THIRTEEN OUTLAWS LLC HOPE PHYSICAL THERAPY-PARKING LOT

SITE DEVELOPMENT PLAN HOPE PHYSICAL THERAPY-PARKING LOT	THIRTEEN OUTLAWS, LLC	4850 AUSTIN BLUFFS PKWY COLORADO SPRINGS, CO 80918
# Date	Issue / Description	Init.
- - - - - - - - -		
Project No:		HPT01
Drawn By:		ASA/MRK
Drawn By: Checked By:		ASA/MRK CRD

V1_Site Development Plan 2.pdf Markup Summary

Sheet 1 of 8

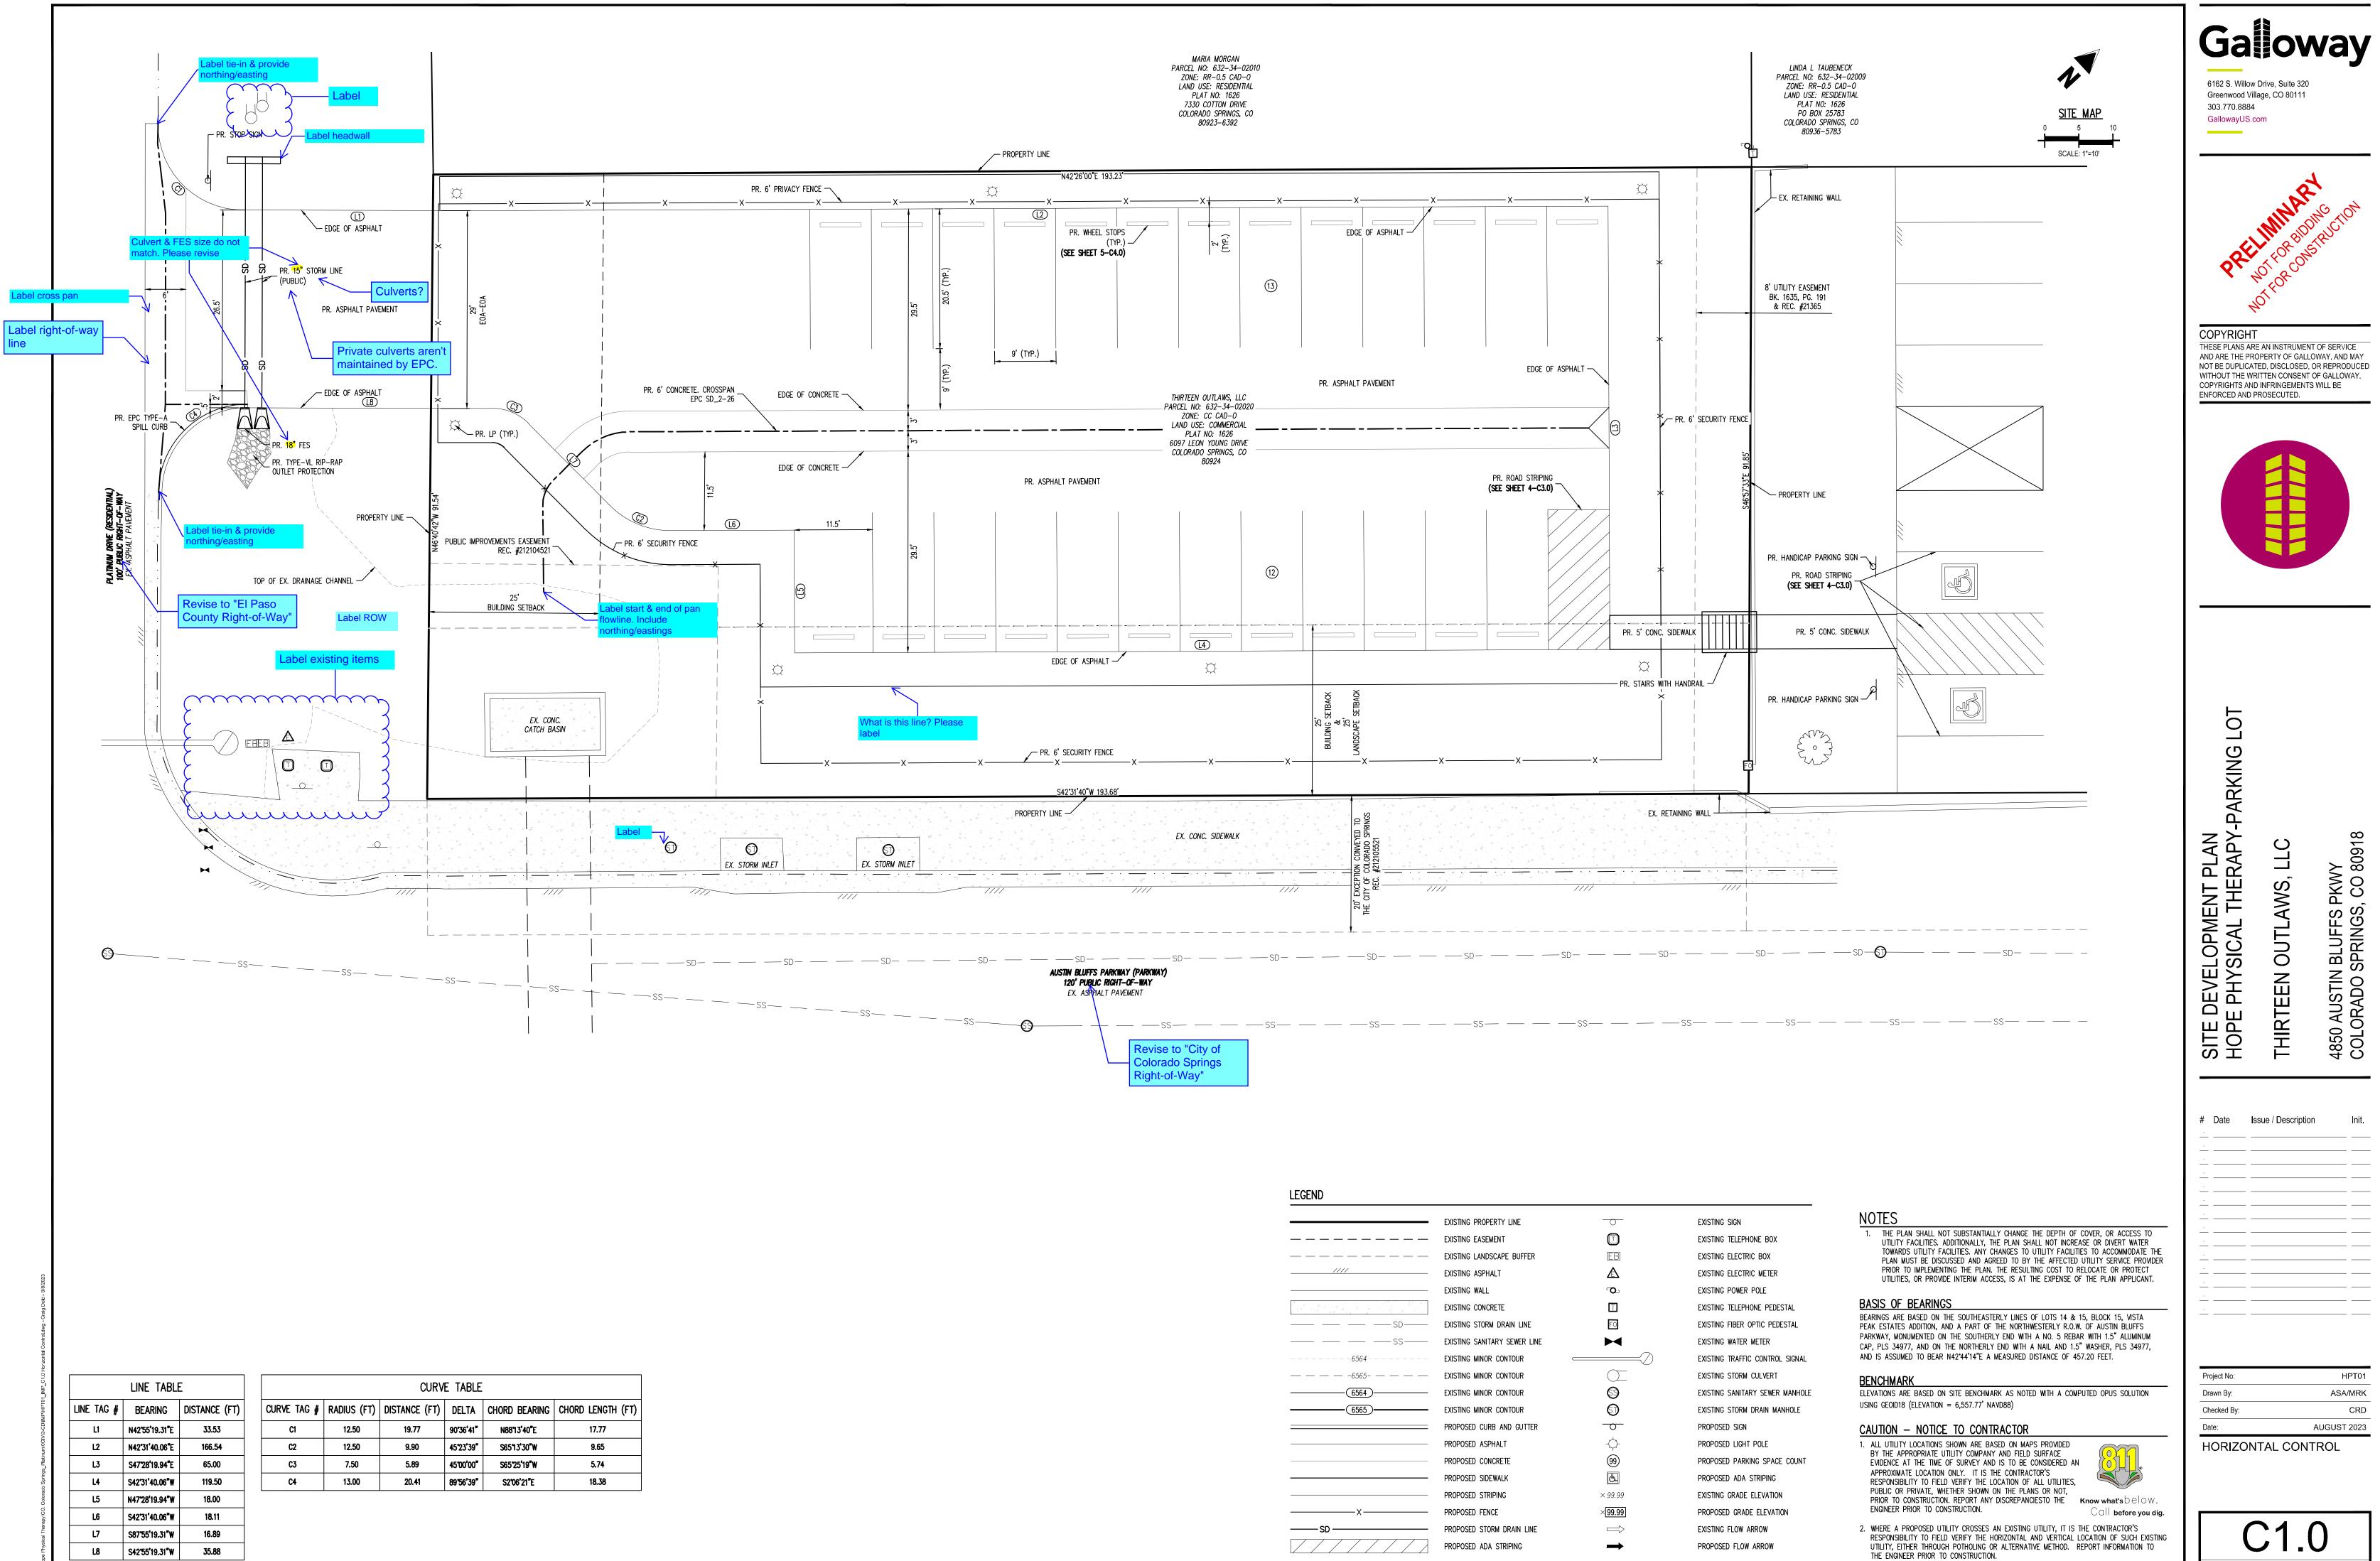
emove EPC Engineerir gnature Block. There do ot appear to be any public

Sheet 2 of 8

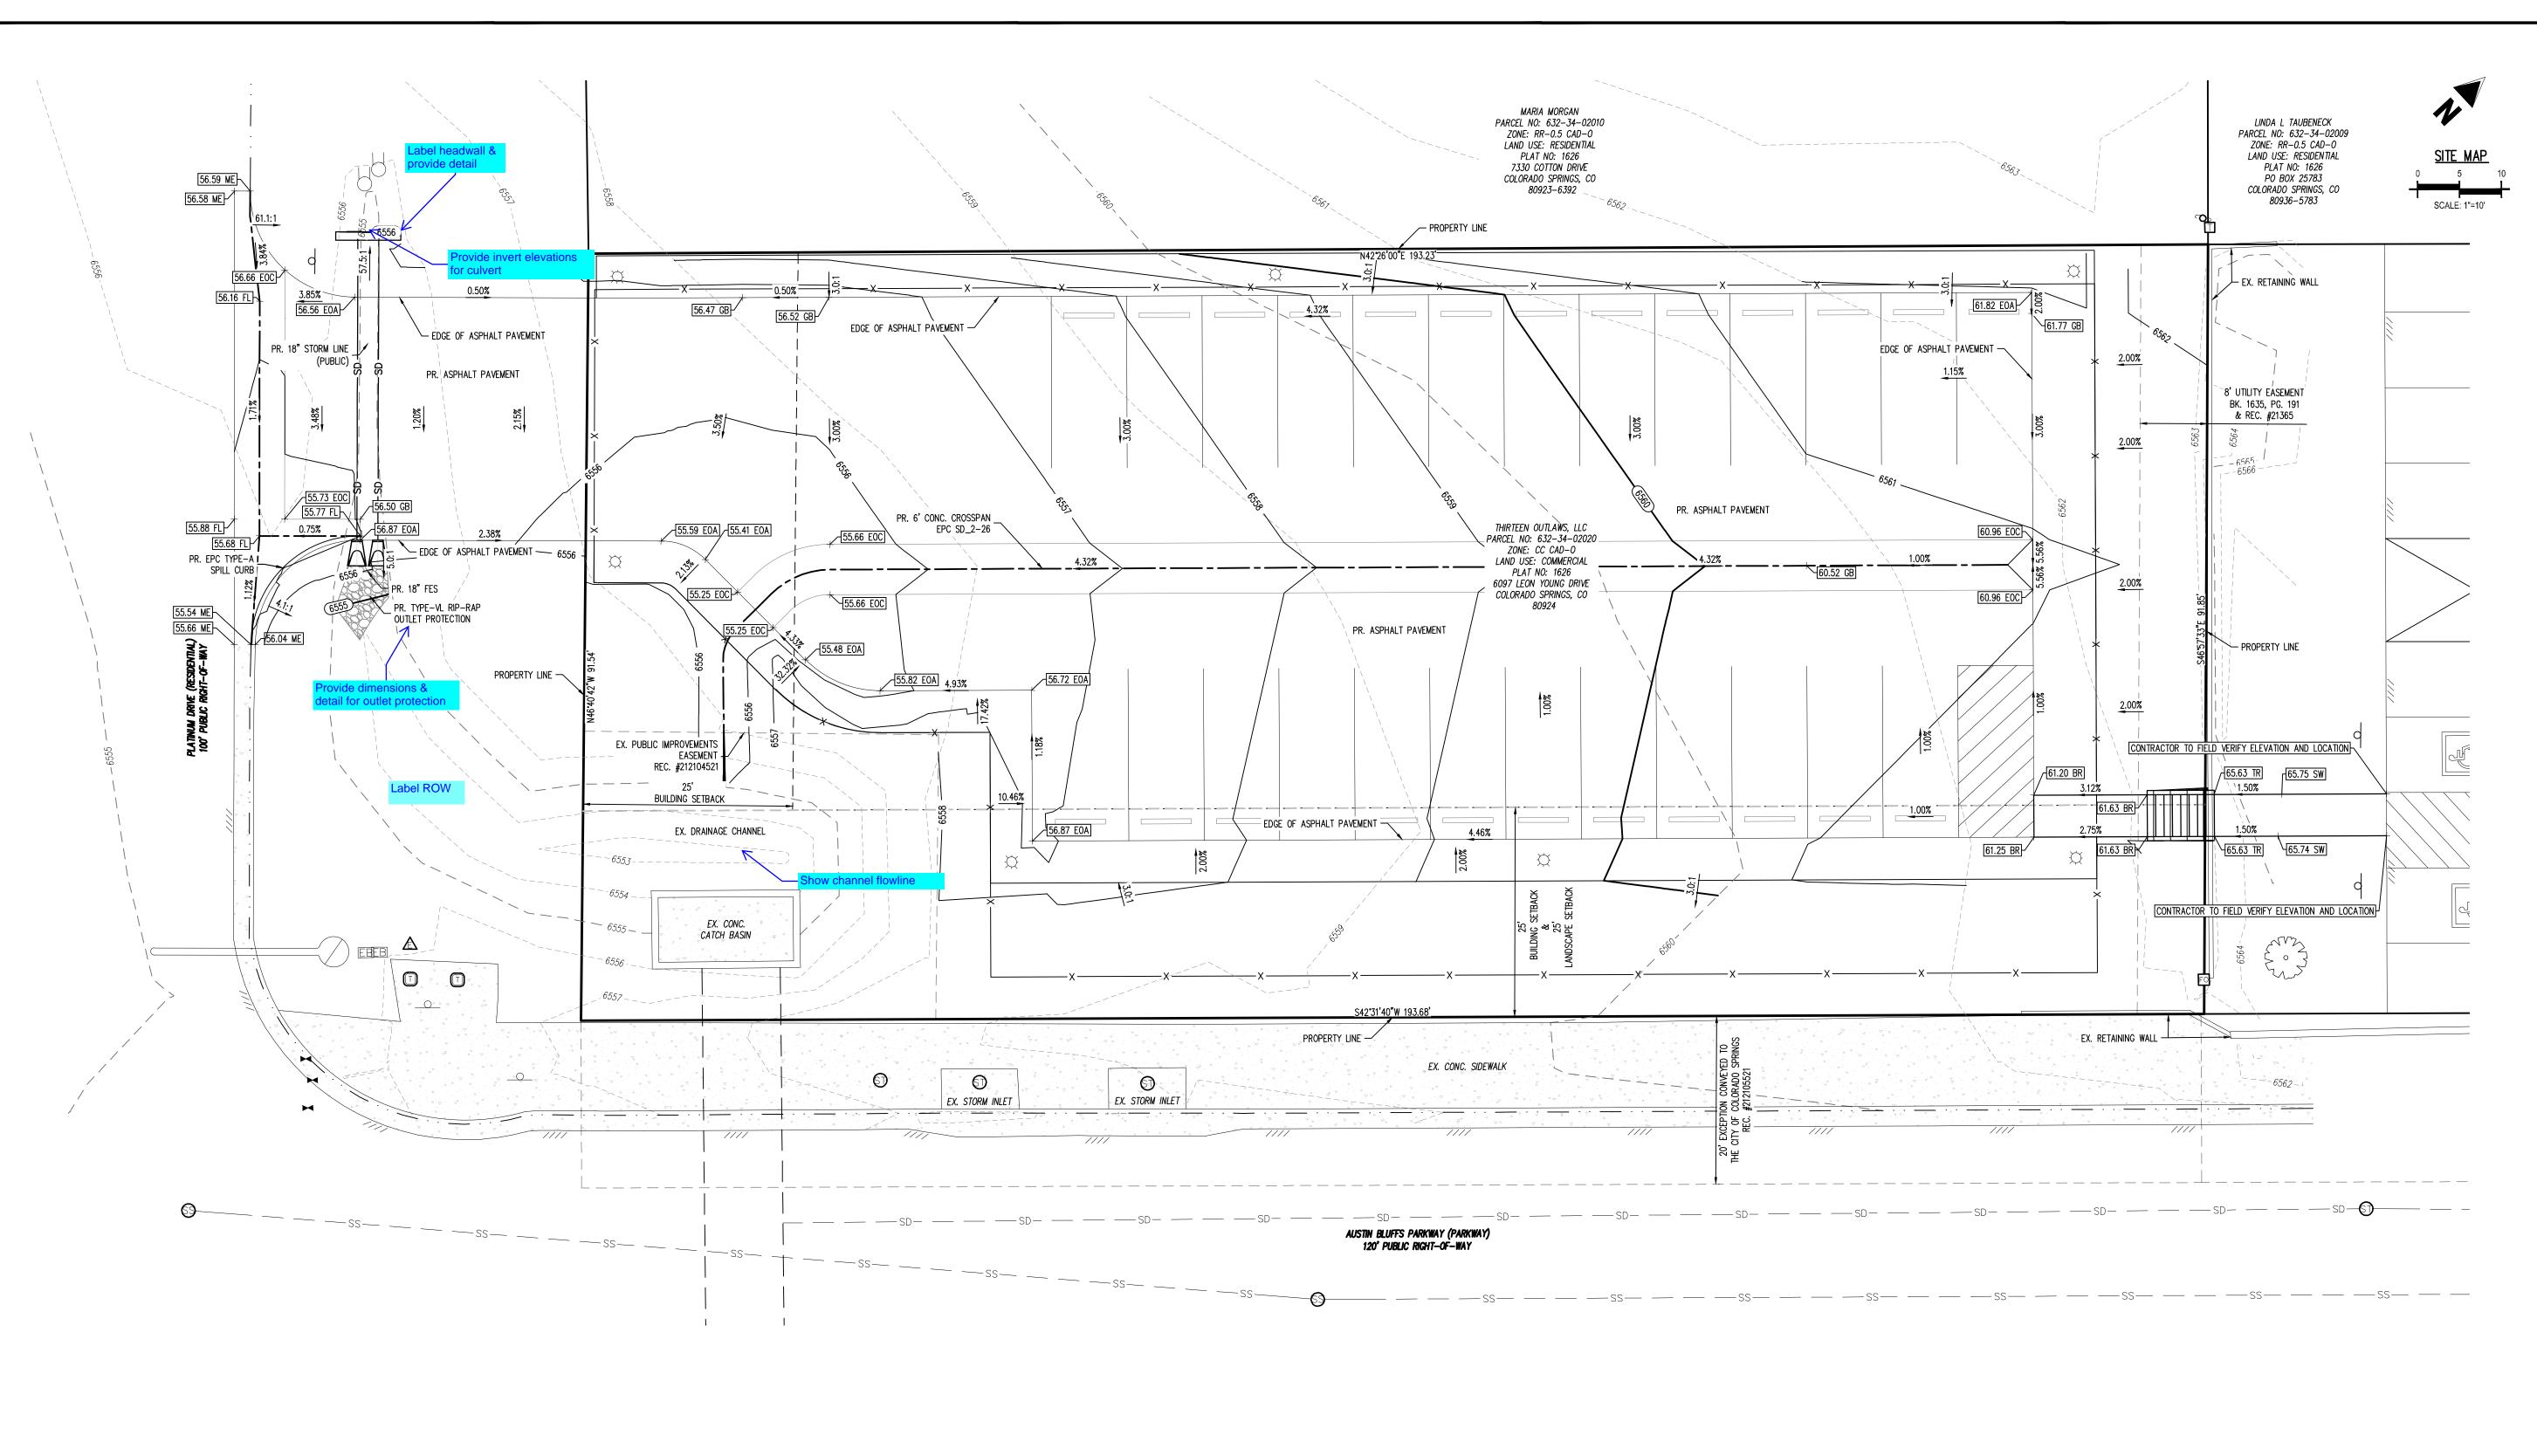
Callout (23)		
Region of Contraction of Contractio	Subject: Callout Page Label: [1] 1 COVER SHEET Author: Carlos Date: 9/26/2023 5:07:59 PM Status: Color: Layer: Space:	Remove EPC Engineering Signature Block. There does not appear to be any public improvements.
	Subject: Callout Page Label: [2] 2 HORIZONTAL CONTROL Author: Carlos Date: 9/26/2023 5:11:30 PM Status: Color: Layer: Space:	Label right-of-way line
P 9 6. succe of	Subject: Callout Page Label: [2] 2 HORIZONTAL CONTROL Author: Carlos Date: 9/26/2023 5:12:09 PM Status: Color: Layer: Space:	Revise to "El Paso County Right-of-Way"
	Subject: Callout Page Label: [2] 2 HORIZONTAL CONTROL Author: Carlos Date: 9/26/2023 5:12:31 PM Status: Color: Layer: Space:	Revise to "City of Colorado Springs Right-of-Way"
15' STOPM LIAE LUC) Culverts? PR. KSPHALT PARADOUT	Subject: Callout Page Label: [2] 2 HORIZONTAL CONTROL Author: Carlos Date: 9/26/2023 5:14:09 PM Status: Color: Layer: Space:	Culverts?

B In it som ar Place Place Place cubers and Place cubers and Place cubers and B In it som ar Place cu	Subject: Callout Page Label: [2] 2 HORIZONTAL CONTROL Author: Carlos Date: 9/26/2023 5:14:25 PM Status: Color: Layer: Space:	Private culverts aren't maintained by EPC.

Subject: Callout Page Label: [2] 2 HORIZONTAL CONTROL Author: CDurham Date: 10/3/2023 2:54:09 PM Status: Color: Layer: Space:	Culvert & FES size do not match. Please revise
	Subject: Callout Page Label: [2] 2 HORIZONTAL CONTROL Author: CDurham Date: 10/3/2023 2:54:20 PM Status: Color: Layer: Space:	Label cross pan
	Subject: Callout Page Label: [2] 2 HORIZONTAL CONTROL Author: CDurham Date: 10/3/2023 2:54:35 PM Status: Color: Layer: Space:	Label headwall
What is this line? Please label	Subject: Callout Page Label: [2] 2 HORIZONTAL CONTROL Author: CDurham Date: 10/3/2023 2:54:54 PM Status: Color: Layer: Space:	What is this line? Please label
	Subject: Callout Page Label: [3] 3 DETAIL GRADING Author: CDurham Date: 10/3/2023 2:55:40 PM Status: Color: Layer: Space:	Show channel flowline
Label Vo	Subject: Callout Page Label: [2] 2 HORIZONTAL CONTROL Author: CDurham Date: 10/3/2023 2:55:57 PM Status: Color: Layer: Space:	Label

Subject: Cloud+ Page Label: [2] 2 HORIZONTAL CONTROL Author: CDurham Date: 10/3/2023 2:53:09 PM Status: Color: Layer: Space:

Label existing items
